**STAFF RECOMMENDATION**

**1012 Mansfield Avenue**

**August 18, 2021**

**Application:** New Construction-Materials; Violation/Show Cause

**A:** Photographs

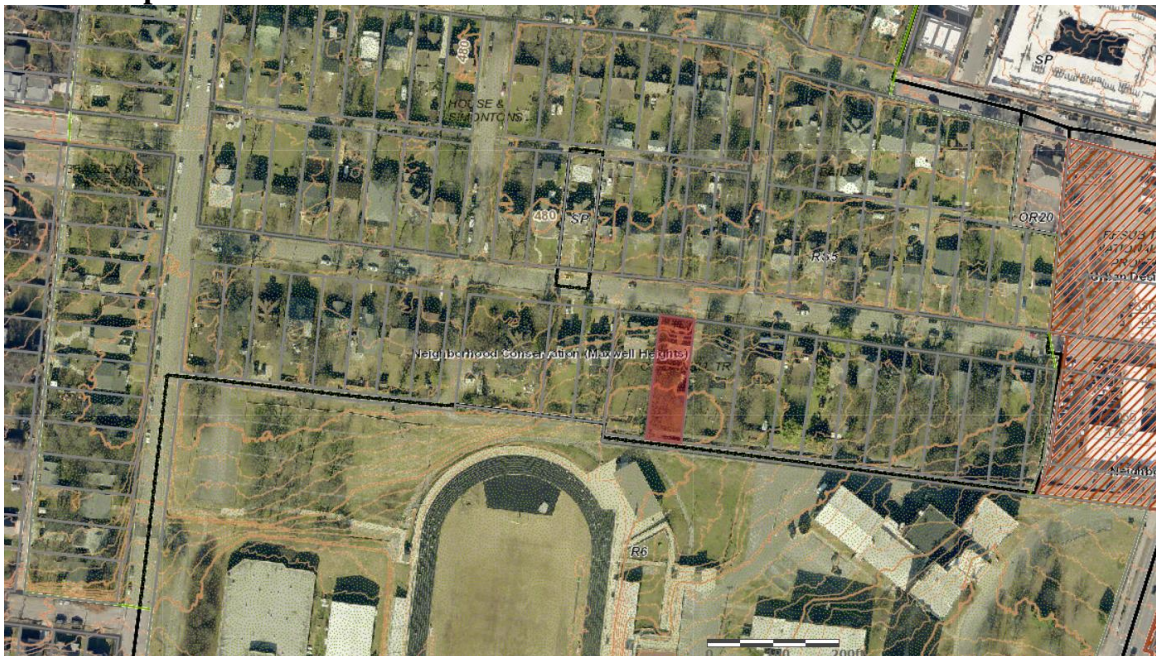
The permit was approved for double hung windows. The windows that were installed are 6/6 double hung with an interior grille (see Figure 1 and 4). The grilles do not meet section IV.C. of the guidelines for materials.

Figure 2: Installed lap siding has a faux grain, specifically called out in the design guidelines as an inappropriate material.

Staff recommends disapproval of the new windows and the siding on 1012 Mansfield Avenue finding that these materials do not meet Section IV.B and IV.C of the guidelines. Staff recommends that the new windows and siding be removed and replaced with compatible materials within sixty (60) days of the Commission's decision.

1 Copy of Rear  
1/8" = 1'-0"

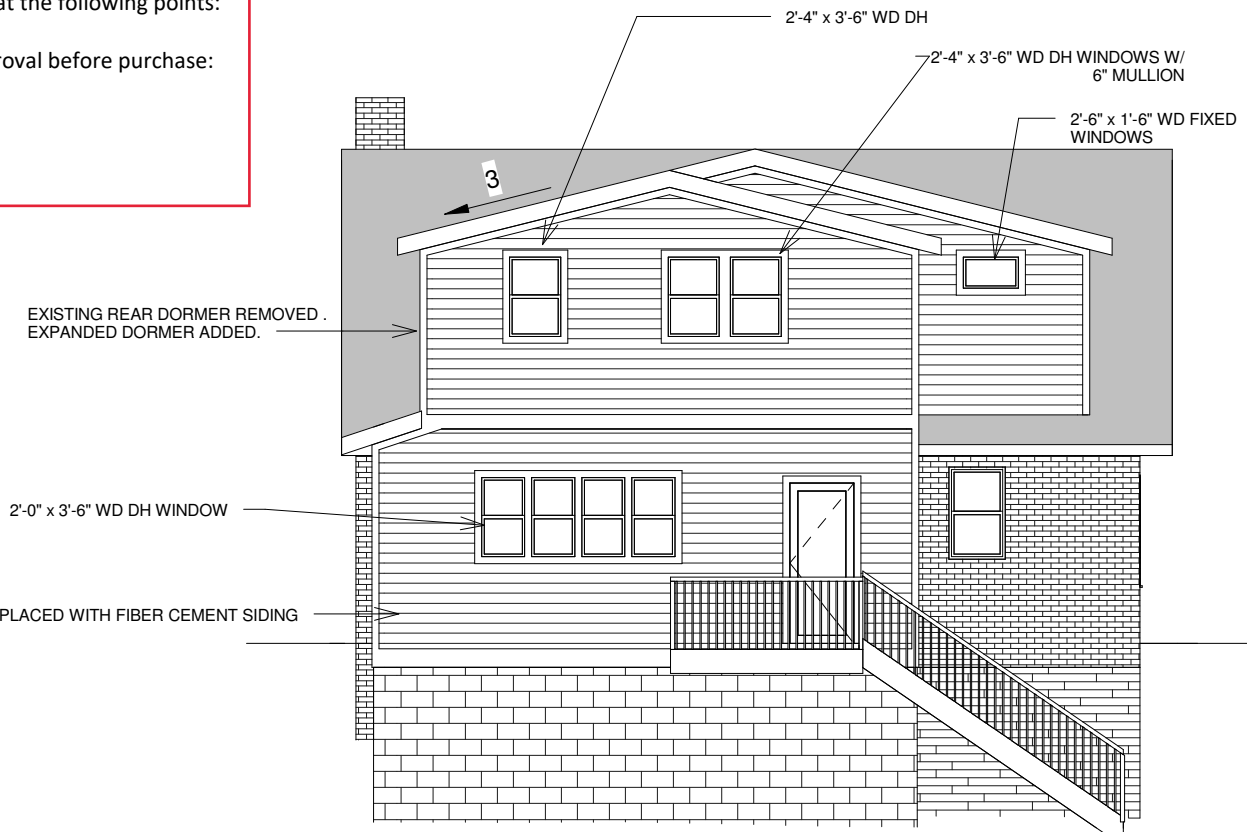
**Proportion and Rhythm of Openings:** The location and dimensions of windows does not match what was originally requested; however, the location of new construction is on the rear of the house in a minimally visible location and the windows meet a historic rhythm of openings.

**Windows:** Windows with between-the-glass muntins were installed without prior approval. Windows were listed on the permit as a feature that needed review prior to purchase and installation. In addition, the first page of the permit states that “windows shall have single-light or fully-simulated, divided-light sashes” with “an exterior muntin, interior munity, and spacer” bar. Staff added notes to the attached drawings repeating this information and the need for prior approval.
